Modifications to car parking area.

Job Title: **New Residential Development 9 – 11 Smedley Lane Cheetham Hill**

Drawing Title: **Car parking setting out**

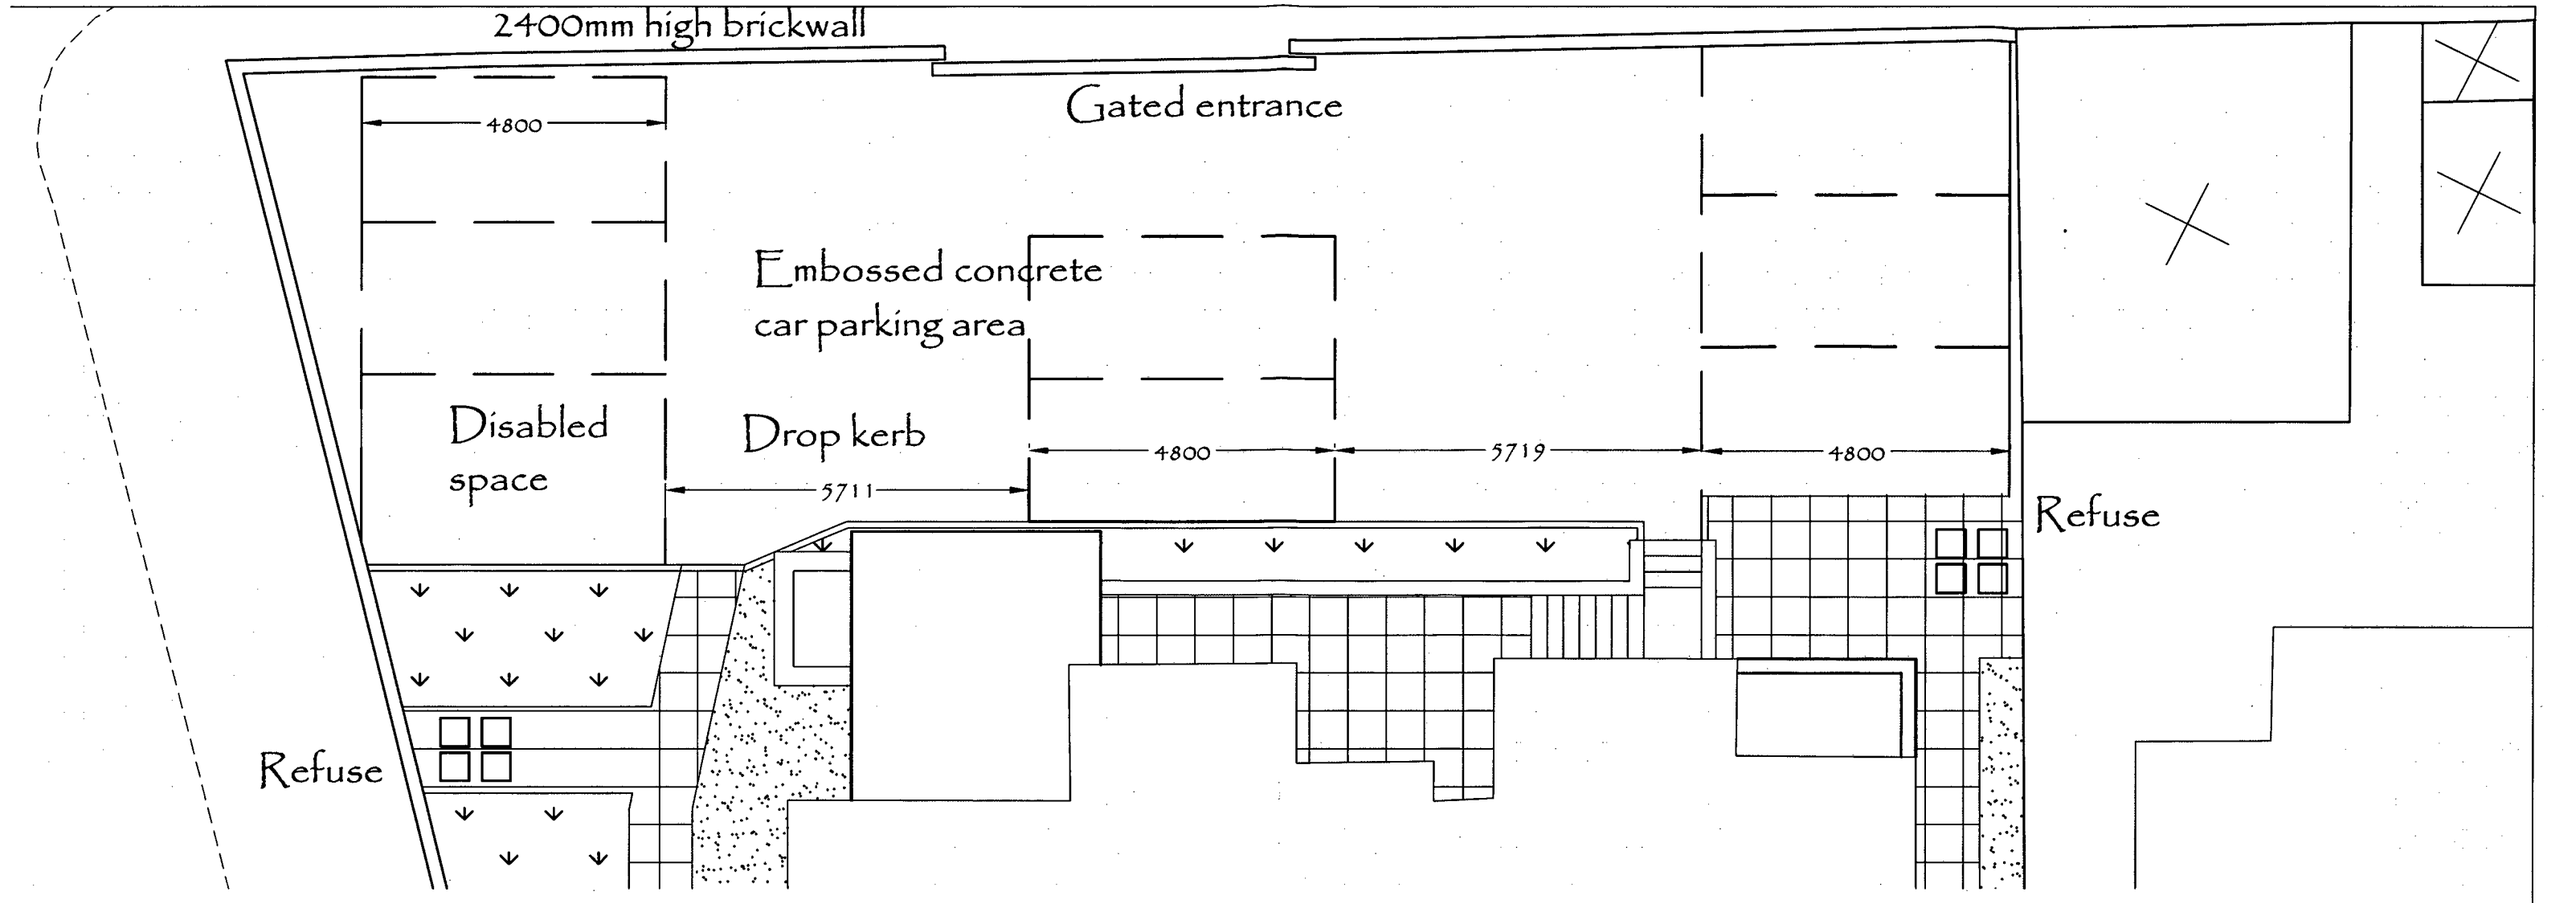
1. Car parking layout revised for one entrance access (Existing entrance)
2. Refuse area relocated in two seperate areas (One area in approved drwg.)
3. Clear access provided on both sides of the property.
4. Car turning ability increased from approved drwg. (5.7+ m against 5.6m and 3.6m)

Rev A: 7th Dec 2010: Disabled car parking bay revised, stone paving footpath added
